Landing Gear Maintenance Report

E145 LH MLG LEG STRUT ASSY & SHOCK ABSORBER

**ELEB****CUSTOMER
SUPPORT****ELEB Equipamentos Ltda.**
Rua Itabaiana, 40 – 12237-540 - São José dos Campos - SP – Brazil**Technical Disposition****ELEB-TD 2022-029822**

SUBJECT**EMB-145 - MLG Axle Repair Procedure****CONTACT****To:** Hawker Pacific Aerospace (HPA)
Phone: +1 (818) 765-6201 ext. 449
dario.contreras@hawker.com**From:** ELEB Customer Support Engineering
Phone: + 55 12 3935-5313/5456/5216
technicalsupport.eleb@embraer.com.br**IDENTIFICATION**

IDR 37146

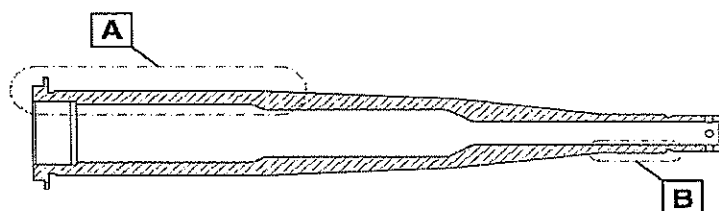
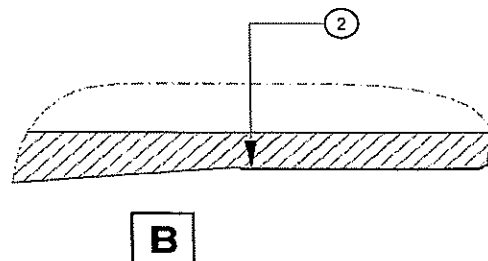
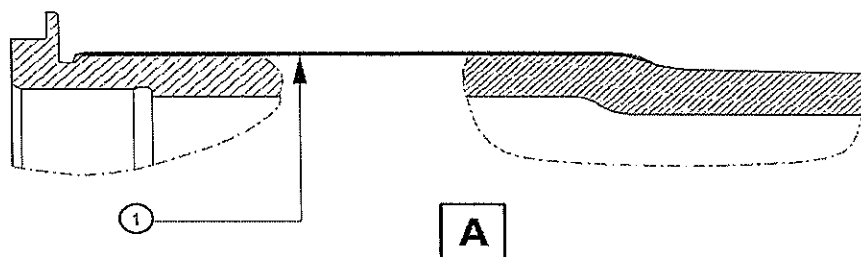
DIA (2) O/D
HAS BEEN MACHINED U/S TO REMOVE CORROSION

" To remove corrosion, the subject part's outer diameter (2) was machined beyond the post rework dimensions as indicated the drawing below. All other dimensions within CMM limits.

- Restore the OD to design dimension by chrome plating in accordance with Service Bulletin 145-32-0114, if the part is structurally acceptable.
- Refinish will be completed per CMM."

Provided that the following instructions are accomplished, ELEB's Engineering states that this Component can be structurally and functionality acceptable to return to service:

1. Refer to CMM TP 145/1170_32-10-01;
2. Perform a NDI according to CMM TP145/1170 _32-10-01 section 501"CHECK";

3. If no cracks and corrosion is found, repair the axle according to SB 145-32-0114 or CMM TP 145/1170, section 601 instructions (whichever is applicable);

NOTE: The chrome plating thickness must be enough to reach the final dimension according to figure 01 Sheet 02 of this Service Bulletin (oversize chrome plating will be necessary for this case) or CMM TP 145/1170 – Section 601, Figure 606 - Sheet 2 (whichever is applicable);

IDR 37234

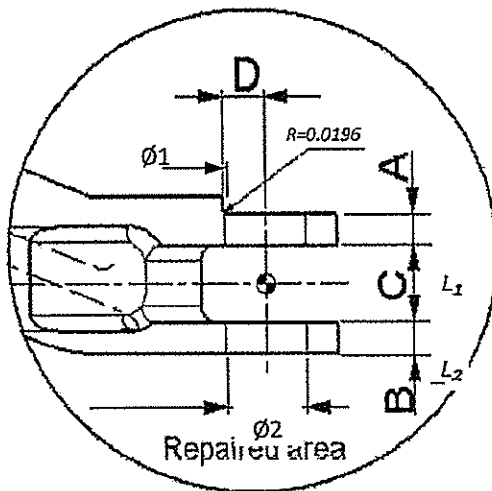
IDR Document No. 37234	Rev. No. 0	Date 9/8/2022	Sales Order No. 660041923	Work Order No. 51680175	
Part Description DOOR FITTING ASSY	Part Number 2309-2017-501		Serial Number N/A	A/C Type ERJ-145	CMM 32-10-01
Detail Part Description DOOR FITTING	Detail Part Number 2309-2012-001		Detail Serial Number N/A	A/C Tail No. (MSN) N48901	
Description Lug thickness L2 machined undersize to remove corrosion. All other dimensions within CMM limits.					
Proposed Resolution If structurally acceptable, HPA proposes: - Perform NDT to ensure defect free condition. - Fabricate and install repair bushings similar to 2309-5006-005 with over size flange to restore back to design dimensions. - Complete rest of repair in accordance with CMM.

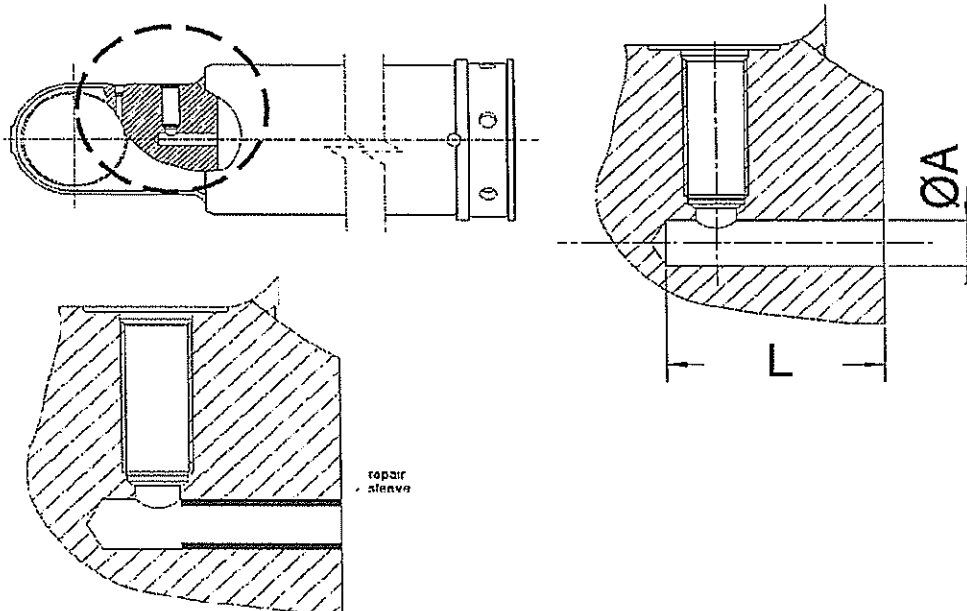
LEVEL TUBE BORE MACHINED O.S TO REMOVE CORROSION

IDR Document No. 37157	Rev. No.	Date 8/31/2022	Sales Order No. 660041980	Work Order No. 51684506	
Part Description PISTON TUBE ASSY	Part Number 2309-2057-003		Serial Number OF3047758/02	A/C Type EMB-145	CMM 32-10-02
Detail Part Description PISTON TUBE	Detail Part Number 2309-2058-001		Detail Serial Number OF147461-2/2	A/C Tail No. (MSN) N11535	
Description Level tube bore machined to remove corrosion. All other dimensions within CMM limits.					
Proposed Resolution 1. Perform stress relief of the part at a temperature of 190°C ± 5°C (374°F ± 9°F) for 4 hours minimum, within 8 hours after grinding. 2. Perform NDT per CMM. 3. Shot peen reworked area per CMM. 4. Fabricate and install a repair sleeve to restore inner diameter. 5. Restoration and refinish in accordance with the CMM.

Section view W-W

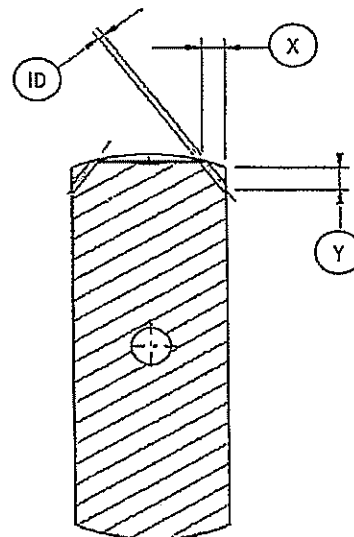
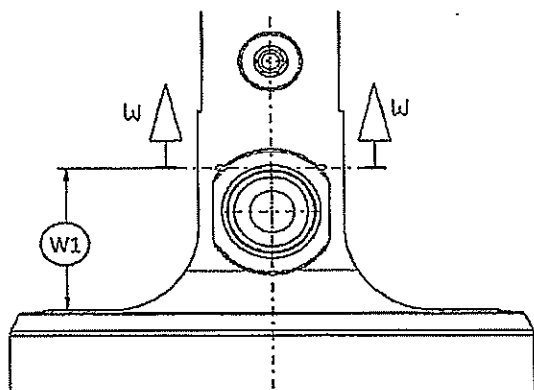
IDR Document No. 37157	Rev. No. 13	Date 9/30/2015	Sales Order No. 660041980	Work Order No. 51684506	
Part Description PISTON TUBE ASSY	Part Number 2309-2057-003		Serial Number OF3047758/02	A/C Type EMB-145	CMM 32-10-02
Detail Part Description PISTON TUBE	Detail Part Number 2309-2058-001		Detail Serial Number OF147461-2/2	A/C Tail No. (MSN) N11535	
Description (see page 1)					
Proposed Resolution (see page 1)

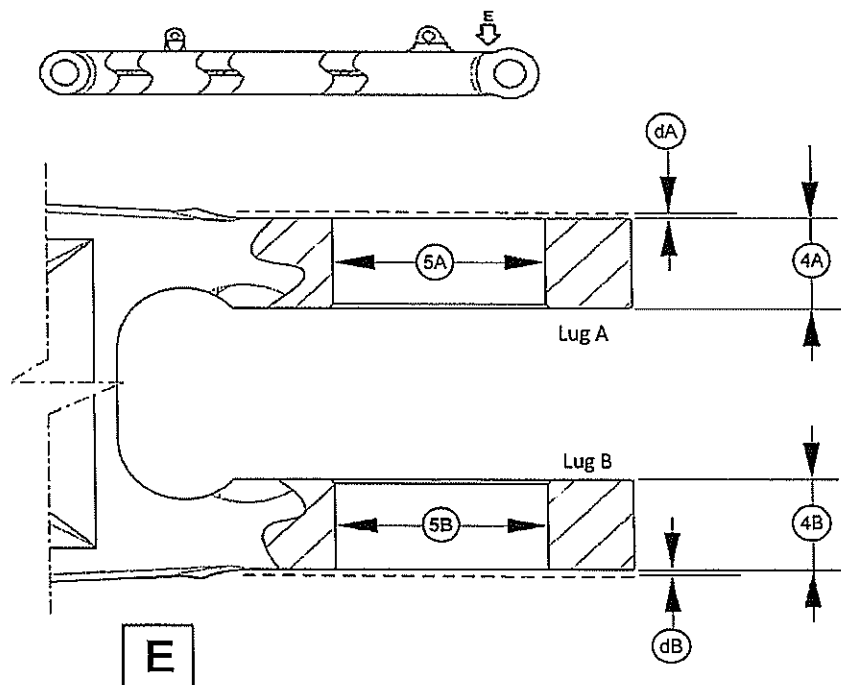
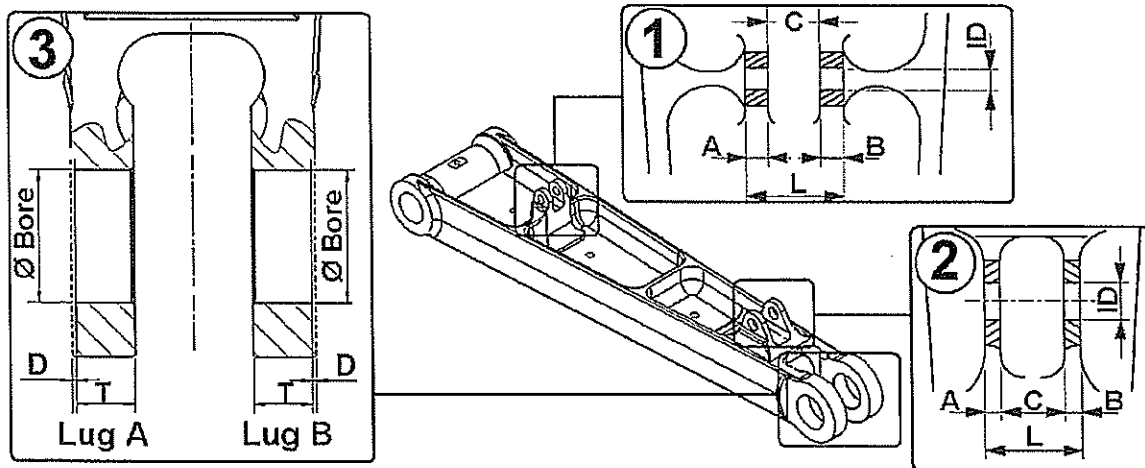
IDR Document No. 37145	Rev. No. 0	Date 9/1/2022	Sales Order No. 660041925	Work Order No. 51680217	
Part Description UPPER MAIN SIDE STRUT ASSY	Part Number 2309-2502-501		Serial Number OF603918-4/06	A/C Type EMB-145	CMM 32-10-03
Detail Part Description UPPER MAIN SIDE STRUT	Detail Part Number 2309-2524-001		Detail Serial Number OF435419-0/17	A/C Tail No. (MSN) N48901	
Description Lug (4A) machined undersize to remove defects. All other dimensions are within CMM limits.					
Proposed Resolution If structurally acceptable, HPA proposes to; - Perform fluorescent penetrant inspection on reworked area - Fabricate and install washer to account for missing material - Complete rest of repair and refinish in accordance with CMM

As reported by HPA through Reference # B, in order to remove corrosion, the MLG Upper Main Side Strut lugs needed to be machined according to dimension shown in the sketch and tables below:

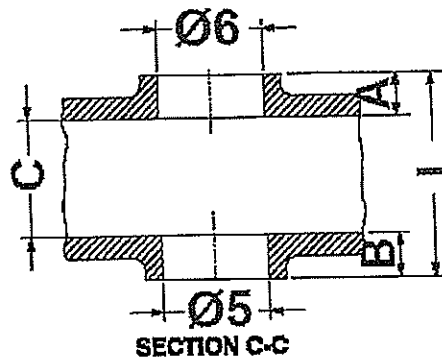
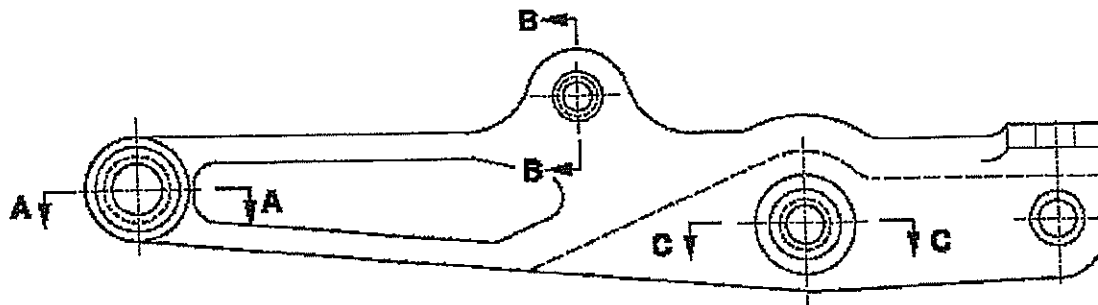
As per reported per reference # B, due to corrosion, the section "C-C" indicated in the figure below needed to be machined beyond CMM limits:

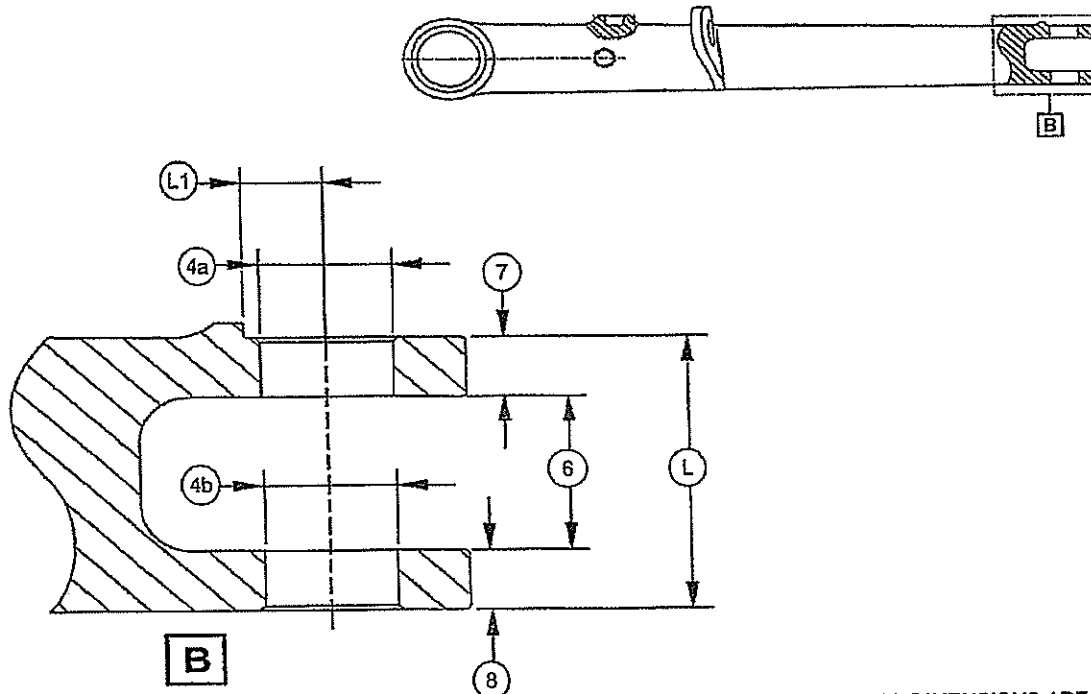
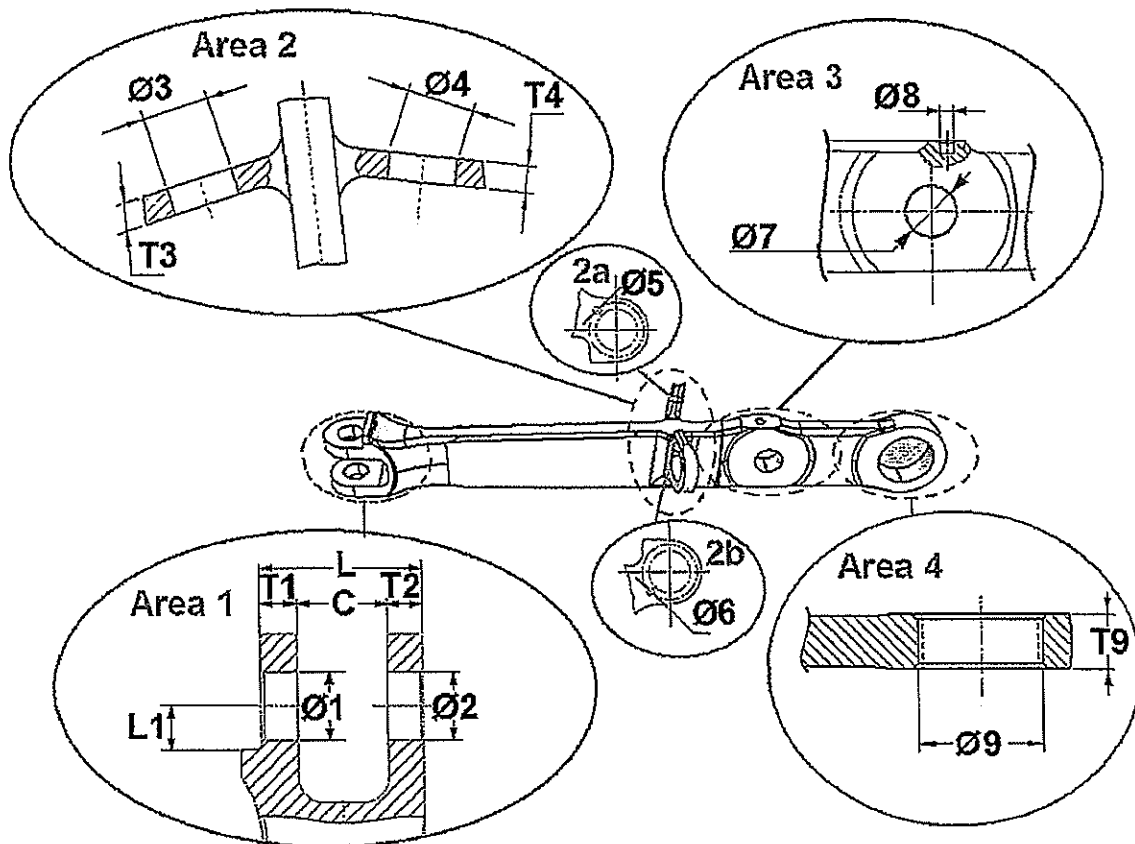
IDR Document No. 37299	Rev. No. 0	Date 9/26/2022	Sales Order No. 660041592	Work Order No. 51669467	
Part Description UPPER STRUT ASSY	Part Number 2309-2608-503		Serial Number OF9462297/03	A/C Type EMB-145	CMM 32-10-04
Detail Part Description UPPER STRUT	Detail Part Number 2309-2611-003		Detail Serial Number 802323-426	A/C Tail No. (MSN) N15986	
Description Outer lug faces machined / bores and lugs machined beyond CMM limits / anti-rotation face machined ...to remove corrosion. All other dimensions within CMM.					
Proposed Resolution - Glass bead peen and NDT all reworked areas. Apply anodizing or Alodine to prevent corrosion. - Fabricate and install bushings to restore dimensions. Restore anti-rotation face dimension with Hysol epoxy. - Complete restoration and refinish in accordance with CMM.

As per reported by Hawker Pacific Aerospace through reference # B, in order to remove corrosion from the bores, inner and outer lugs faces (refer to: Area 1), the subject Upper Secondary Side Strut was re-worked to the final dimensions as noted on the sketch and tables below:

1. Refer to CMM TP 145/1191_32-10-04;
2. Perform NDT inspection as per CMM instructions and make sure the part is free from crack and corrosion;
3. Perform the Glass bead peening treatment to the repaired areas and bearing housing ID according to AMS 2431/6:
 - a. intensity 0.009 to 0.013N,
 - b. shot size AGB-35,
 - c. coverage 125 % minimum.
4. Restore the surface protection per CMM instructions as required (Refer to Table 601);
5. Do the repair bushings P/N 2309-5001-306 installation as per CMM instructions (Refer to table 609 and figure 605);
